# EZ-FILL Software Update

SB165

**PRODUCT NAME: EZ-FILL**

**AFFECTED PART NUMBER: 610-00063 AND 610-00063-001**

Figure 4: H-Bridge Module label

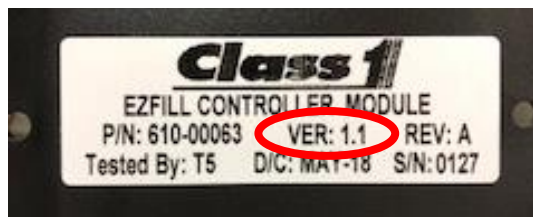
Customers with H-Bridge Module part number 610-00063 or 610-00063-001, with version 1.0, can contact customer service to have them returned and updated to version 1.1. The software version can be found on the Class1 label, affixed on the rear of each H-bridge Module, as seen in Figure 4.
